# Access Compliance Report

## Public Rights-of-Way

### (Curb Ramps)

Intersection ID: 48133	Main Street: WHISTLER'S CHASE DR	Cross Street: ACORN CREEK LN	Location: NW
ADA ID: A3D89906588E	Ramp Type: PerpDiag	Initial Pass/Fail: Fail	Overall Compliance: No
Severity Score: 22.5			
Codes/Mitigation Info/Possible Solution		Field Measurements/Component Compliance

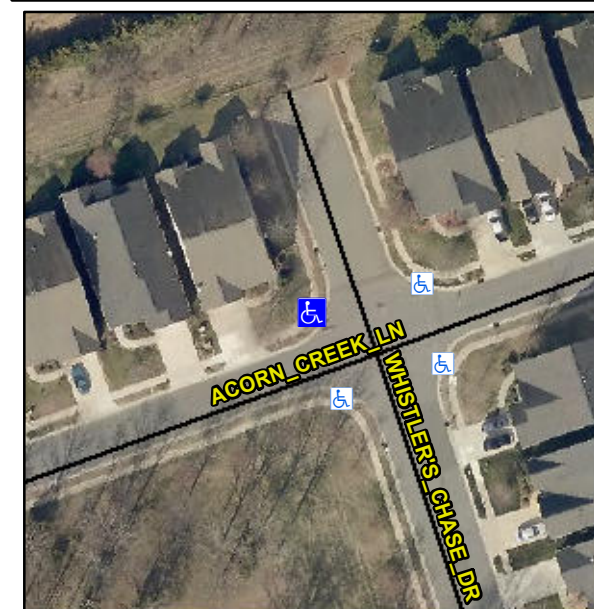
**Not Found, R304.5.1, R304.2.2, R304.5.3**

Compliance	Description	Data	Compliance	Description	Data
N/A	Ramp Length (in)	50.0	No	Ramp Slope (%)	8.4
No	Ramp Width (in)	44.0	No	Ramp XSlope (%)	3.2
N/A	Flare Type LT	N/A	N/A	Flare Type RT	N/A
N/A	Flare Slope LT (%)	N/A	N/A	Flare Slope RT (%)	N/A
N/A	Flare Traversable LT?	N/A	N/A	Flare Traversable RT?	N/A
N/A	Landing Length (in)	N/A	N/A	DWS Provided?	N/A
N/A	Landing Width (in)	N/A	N/A	DWS Contrast?	N/A
N/A	Landing Slope (%)	N/A	N/A	DWS Length (in)	N/A
N/A	Landing X Slope (%)	N/A	N/A	DWS Full Width?	N/A
N/A	Landing Curb? (Y/N)	N/A	N/A	DWS Offset (in)	N/A
N/A	Shared Landing?	N/A			
N/A	Gutter Ponding?	N/A	N/A	Gutter Slope (%)	N/A
N/A	Gutter Lip Ht (in)	N/A	N/A	Gutter X Slope (%)	N/A
N/A	Painted X Walk1?	No	N/A	Painted X Walk2?	No
	X Walk 1 Direction	To S		X Walk 2 Direction	To E
N/A	X Walk 1 Width (in)	N/A	N/A	X Walk 2 Width (in)	N/A
	X Walk 1 Slope (%)	3.9		X Walk 2 Slope (%)	1.8
	X Walk 1 X Slope (%)	0.3		X Walk 2 X Slope (%)	2.9

**Remove & Replace Curb Ramp With Two New Directional Ramps or Equivalent.**
